<b>8.6</b>	<b>17 NOTT STREET, PORT MELBOURNE</b>
<b>LOCATION/ADDRESS:</b>	<b>17 NOTT STREET, PORT MELBOURNE</b>
<b>RESPONSIBLE MANAGER:</b>	<b>GEORGE BORG, MANAGER CITY DEVELOPMENT</b>
<b>AUTHOR:</b>	<b>RICHARD LITTLE, SENIOR URBAN PLANNER</b>
<b>TRIM FILE NO.:</b>	<b>PF16/638120</b>
<b>ATTACHMENTS:</b>	<b>1. 904/2016 - Objector Map 2. 904/2016 - Advertised Plans 3. 904/2016 - 3D Perspective</b>
<b>WARD:</b>	Gateway
<b>TRIGGER FOR DETERMINATION BY COUNCIL:</b>	More than 16 objections
<b>APPLICATION NO:</b>	904/2016
<b>APPLICANT:</b>	Adapt Architecture Pty Ltd
<b>EXISTING USE:</b>	SINGLE DWELLING
<b>ABUTTING USES:</b>	Dwelling
<b>ZONING:</b>	Mixed Use Zone
<b>OVERLAYS:</b>	Design and Development Overlay- Schedule 1-1A, Development Contributions Plan – Schedule 1, Environmental Audit Overlay
<b>STATUTORY TIME REMAINING FOR DECISION AS AT DAY OF COUNCIL</b>	Expired

Construction of a four storey mixed use building comprising ground floor car parking, office and dwelling, removal of four party wall easements and a reduction in the car parking requirements for the office.

Diagram 1: Area of the first floor to be deleted, in red, in accordance with Condition 1c.

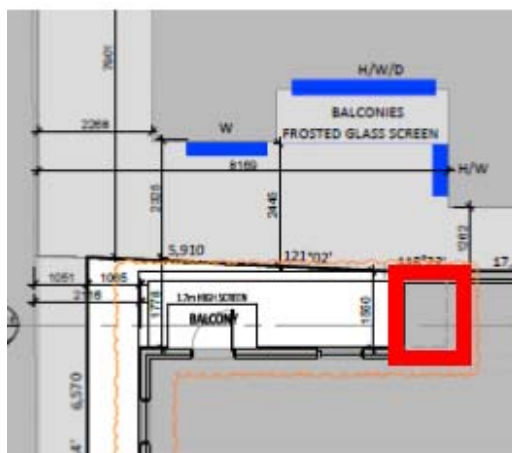
The first floor section of wall would be 1.1m long and have a height of 7.23m from ground level. This section of wall would be located opposite the ground floor courtyard of No. 19-25 Nott Street. Given the height of the wall, it is considered that it would result in loss of amenity to the occupiers of the ground floor apartment through loss of daylight, presentation of visual bulk and creating a sense of enclosure. To reduce the impact to the adjoining ground floor apartment, it is recommended that the length of boundary wall should be reduced by a minimum of 1.18m on the shared boundary and the wall to be setback a minimum of 1.55m opposite the courtyard, as shown in diagram 1 below. **(Refer to condition 1c).**
